Approved Section 4.55 (.....2.....) Modification Application

Project
BARANGAROO STAGE 1B
PUBLIC DOMAIN
Modification S4.55

Drawing Title
**HICKSON PARK WEST ENTRY
DETAIL PLAN - NO TREES**
Drawn
SS

Drawing Title
**HICKSON PARK SECTION
J-J**

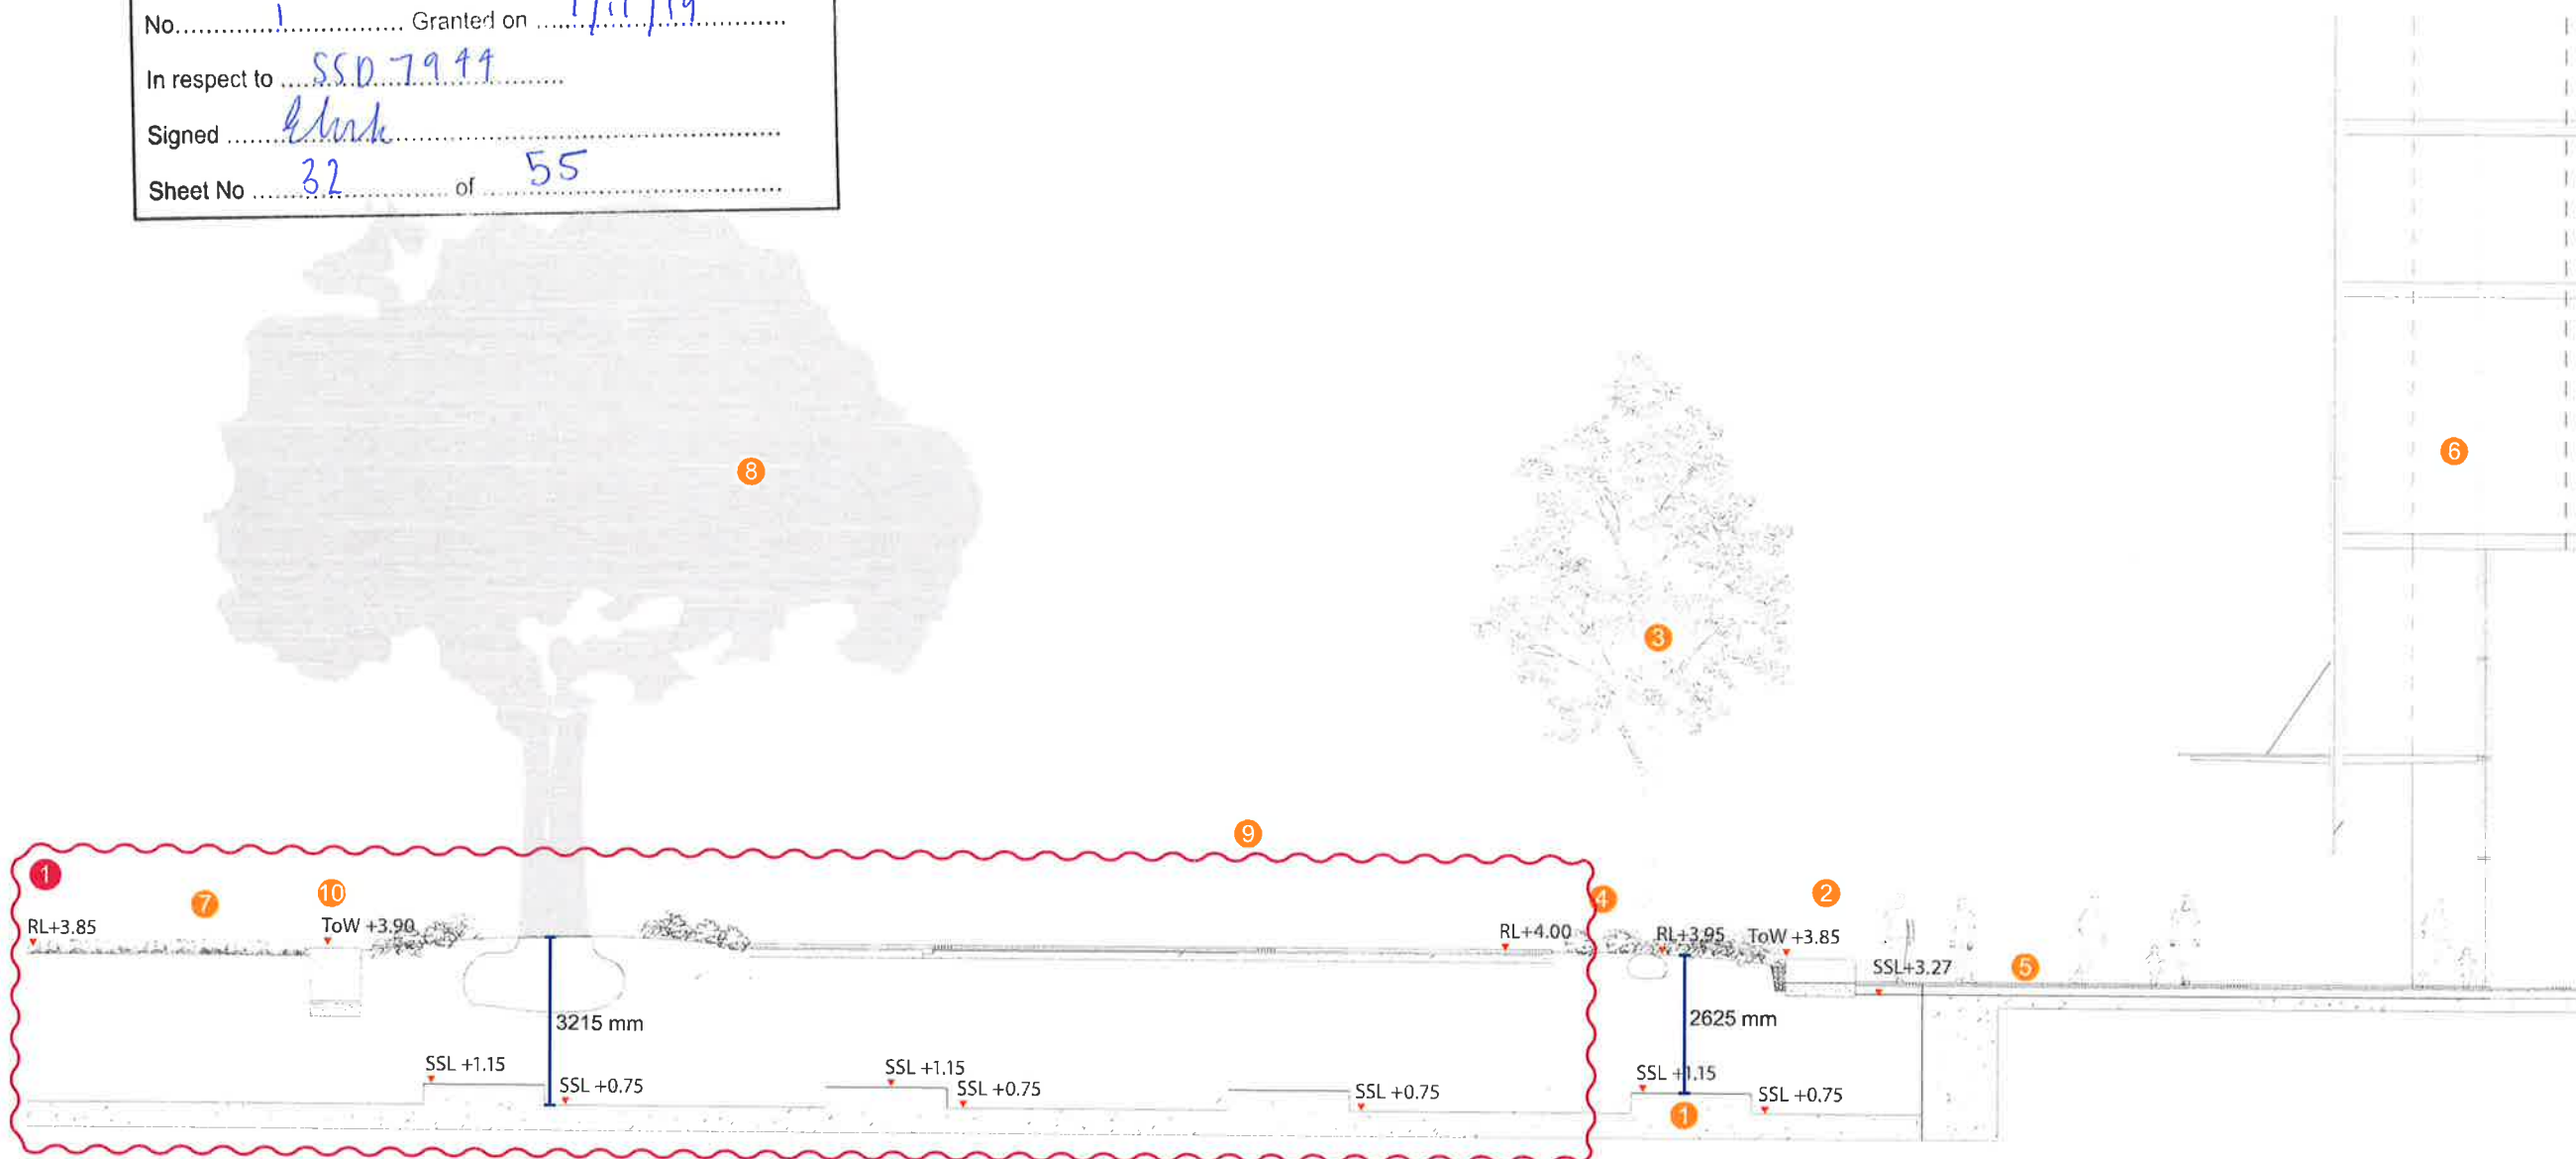
- Amendment cloud
- 1 Levels changed due to proposed Hickson Road levels

Drawing Title
HICKSON PARK SECTION
K-K

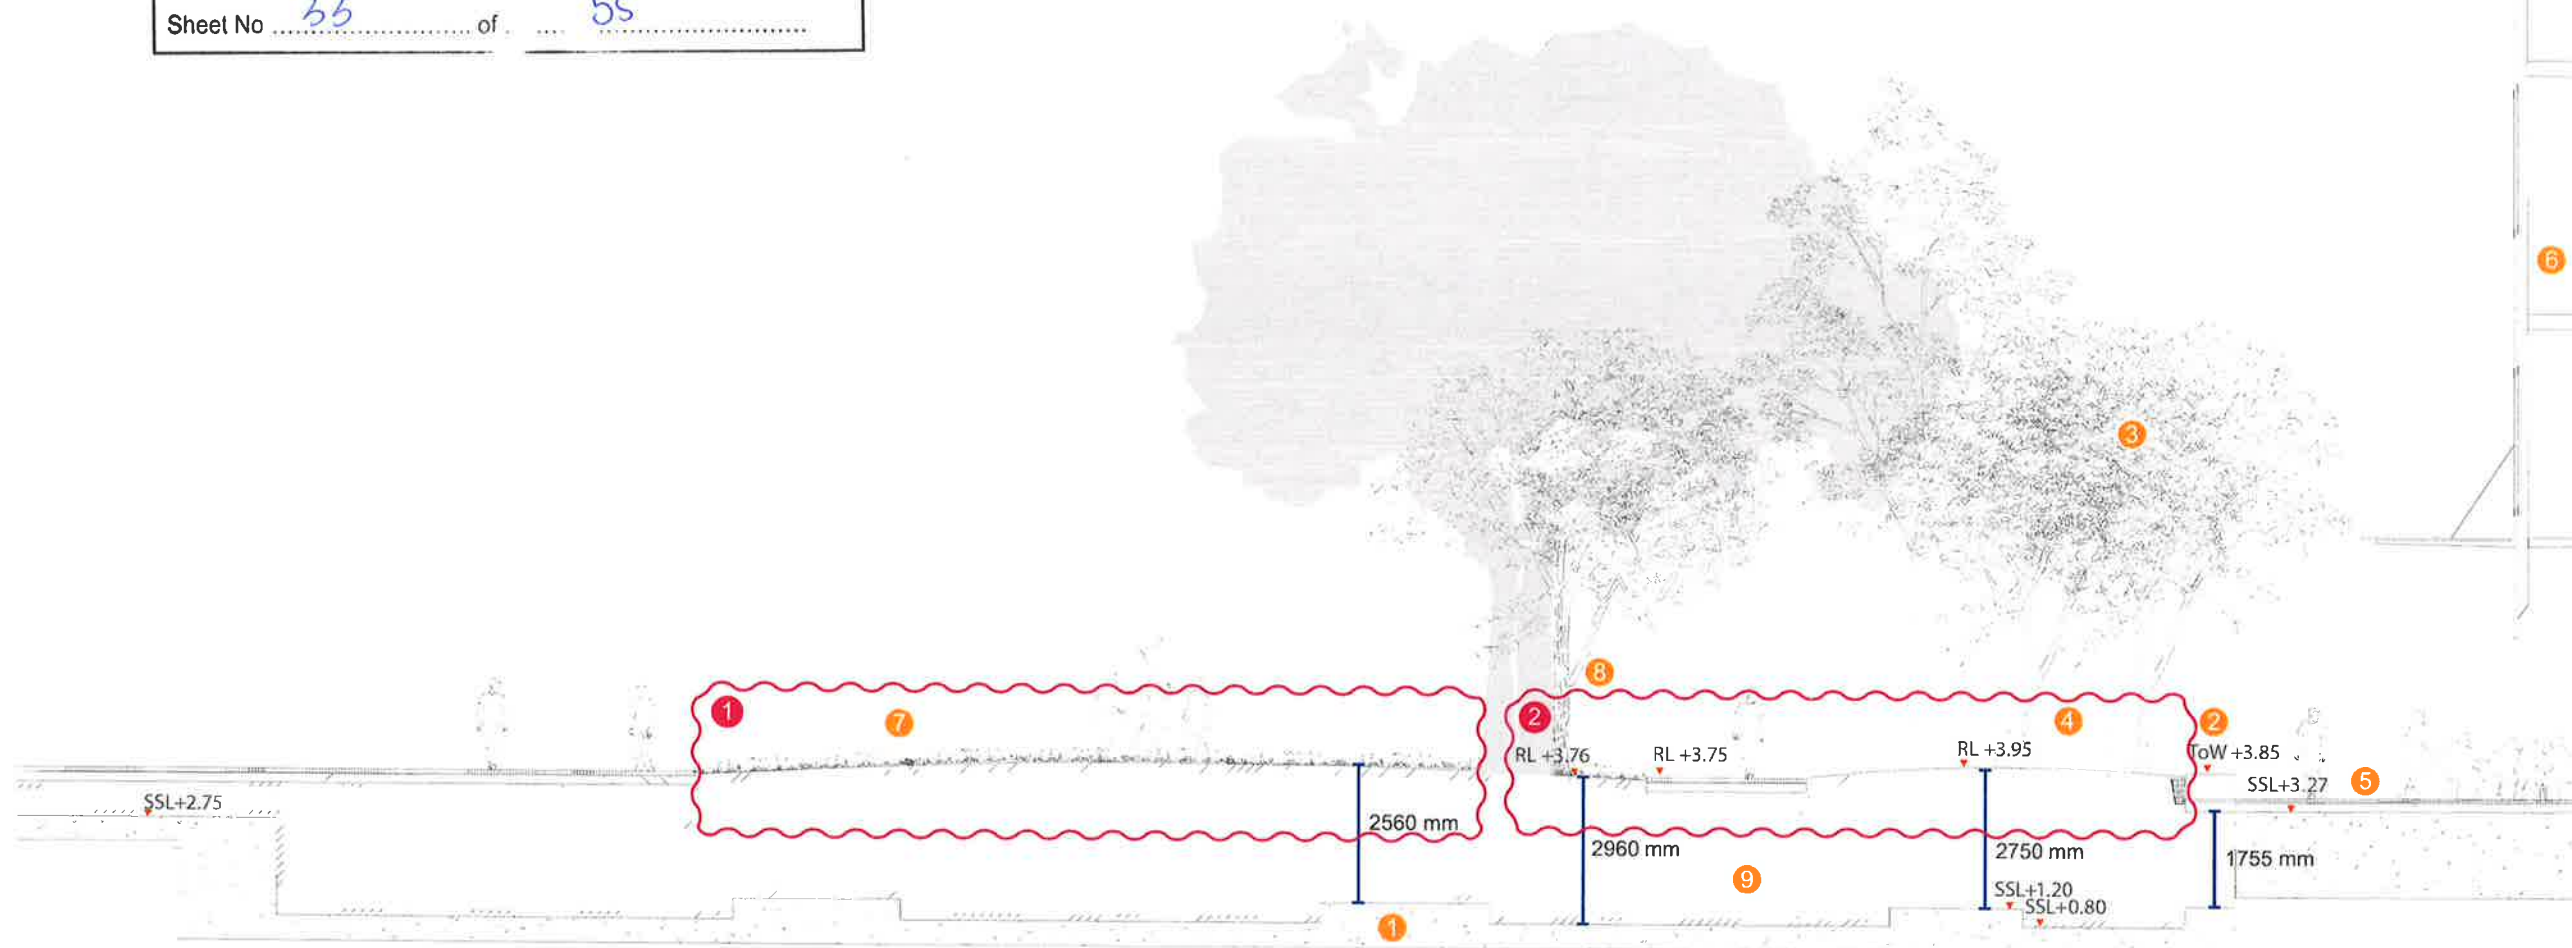
- 1 Levels changed due to proposed Hickson Road levels
- 2 Increase planting area within the park and change of geometry.

Drawing Title
**HICKSON PARK SECTION
L-L**

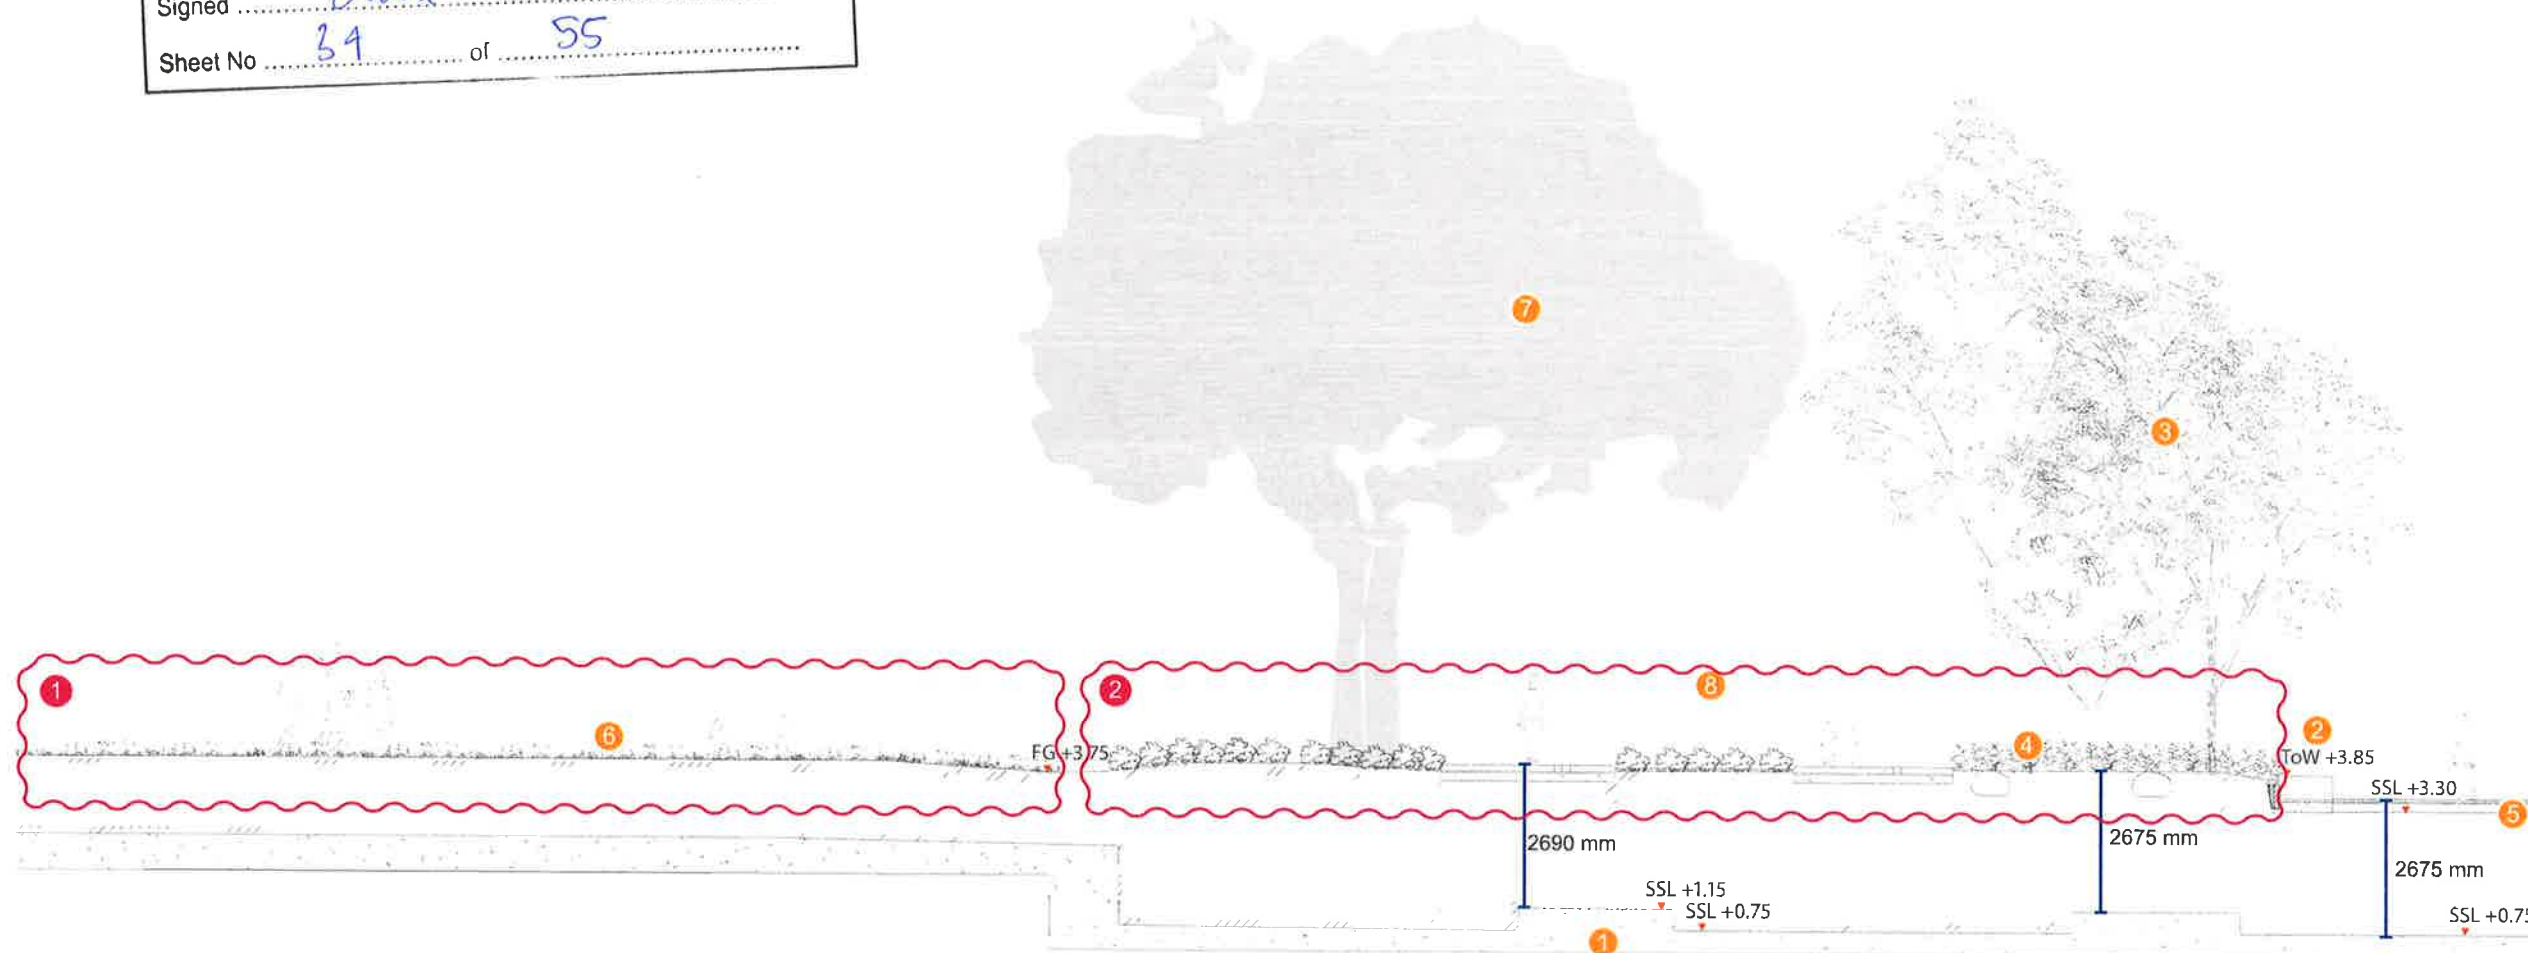
- 1 Levels changed due to proposed Hickson Road levels
- 2 Increase planting area within the park and change of geometry.

Drawing Title
HICKSON PARK SECTION
M-M

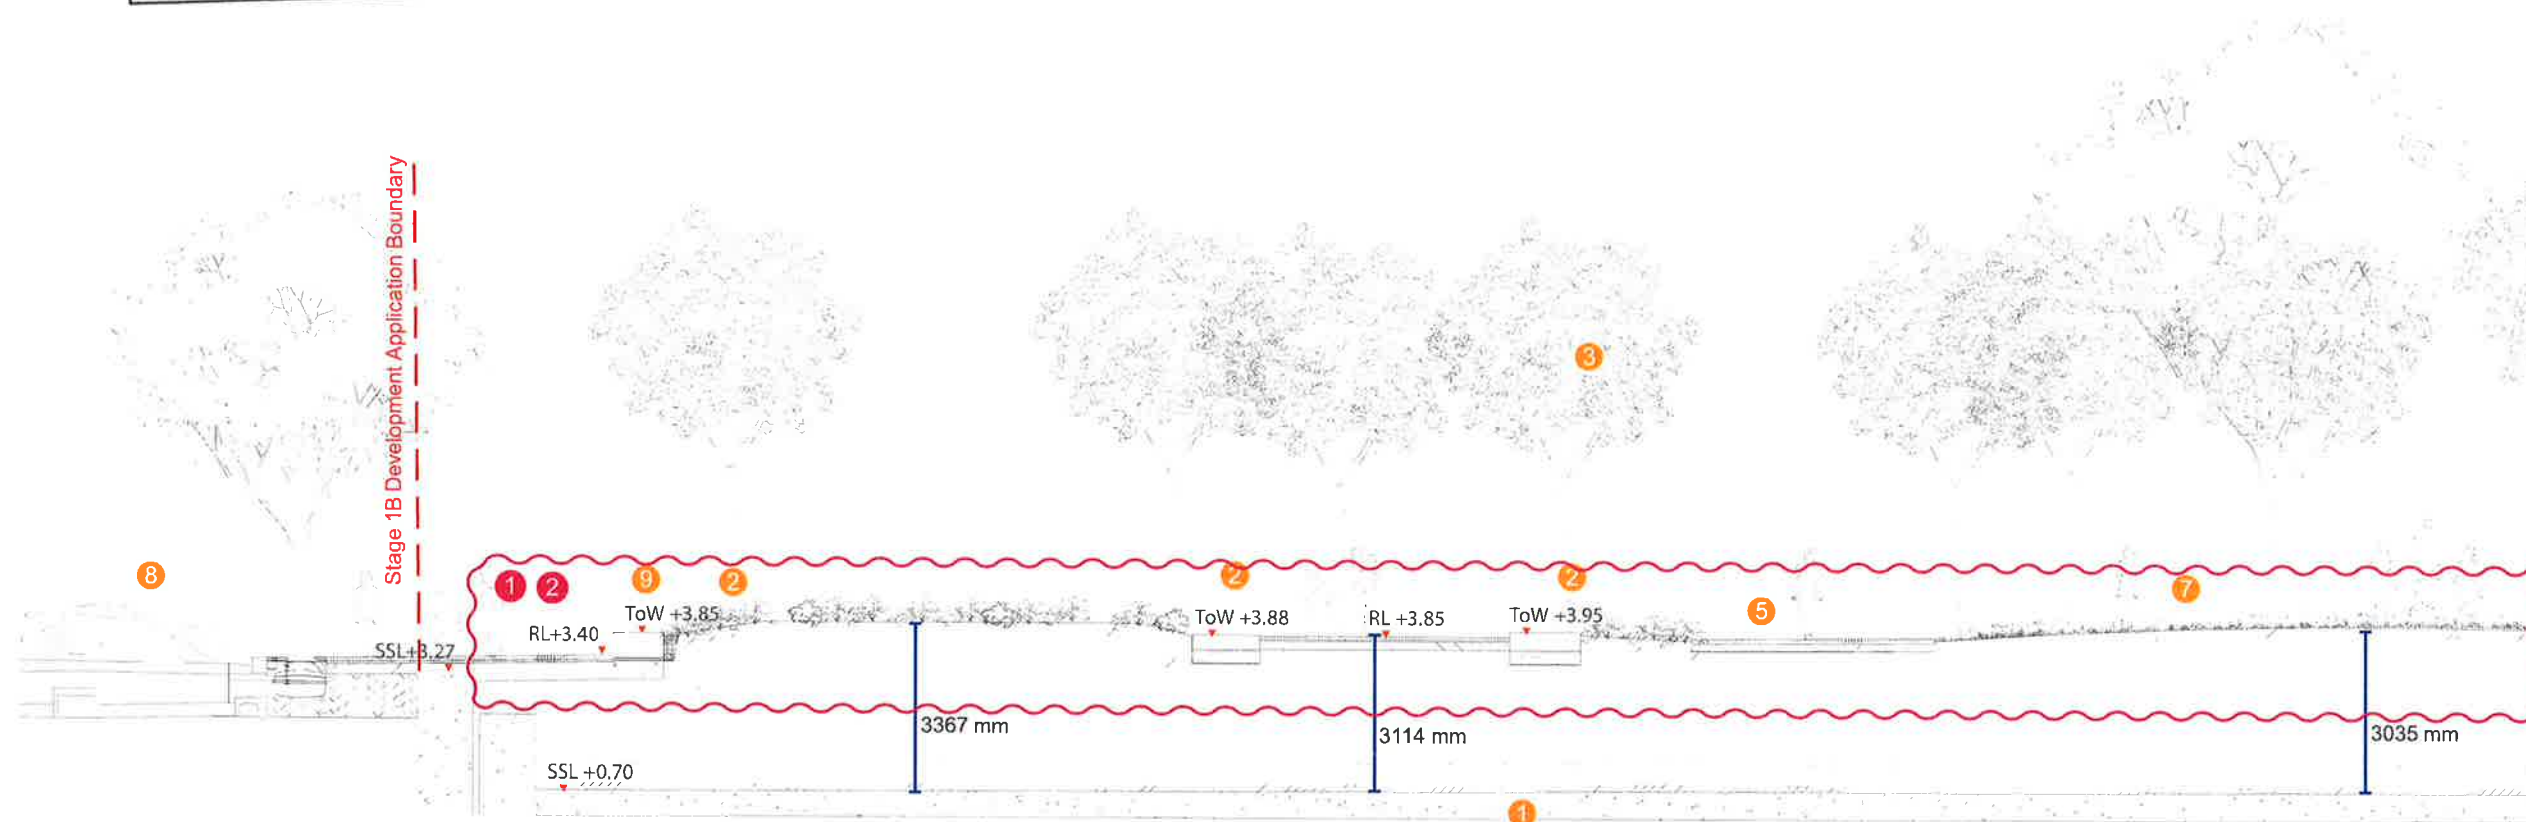
- 1 Levels changed due to proposed Hickson Road levels
- 2 Increase planting area within the park and change of geometry.
